PCN-20210121 TE0726-03 DDR3 Change and Product Update

Company	Trenz Electronic GmbH
PCN Number	PCN-20210121
Title	TE0726-03 DDR3 Change and Product Update
Subject	BOM change
Issue Date	2021-01-25

This change affects Trenz Electronic boards TE0726 of Revision 03: TE0726-03-*

#1 Change DDR3 RAM (U8) from IM4G16D3FABG-125I to IS43TR16256BL-125KBLI

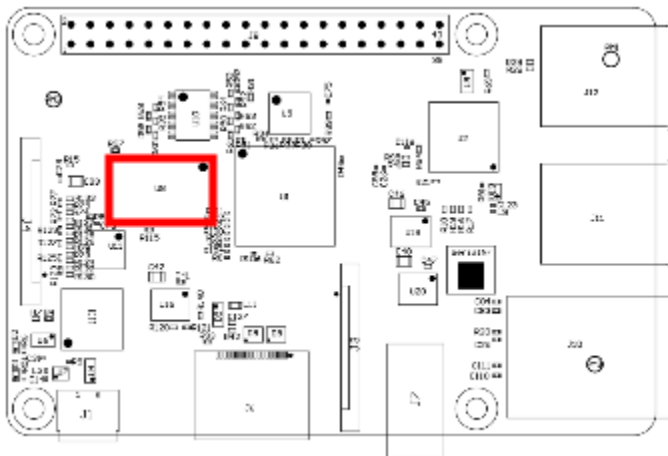
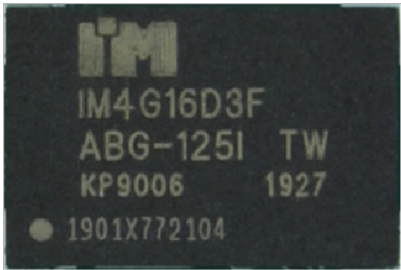
Reason: Component is end of life.

Impact: New DDR timings may be considered in designs.

Locate DDR3 RAM (U8) on top side of PCB:

old	new
IM4G16D3FABG-125I	IS43TR16256BL-125KBLI
